Model 250 RX

Cover plate

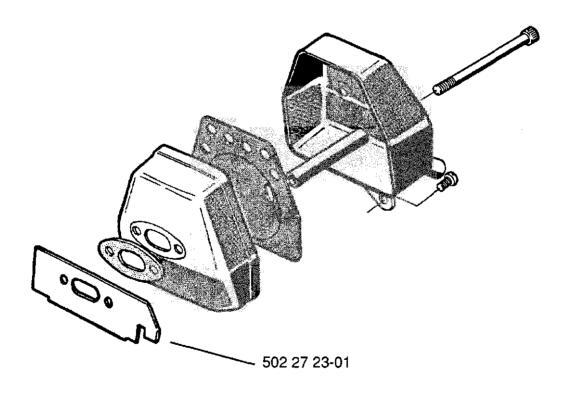
A cover plate is introduced in order to improve the cooling of the engine. The plate is mounted between the cylinder and the silencer. See illustration.

The sealing plate, ref. no. 503 44 77-01, between the cylinder and the silencer is therefore excluded.

New Ref. No. Description 502 27 23-01 Sealing plate

Introduced in production at the end of January 1993.
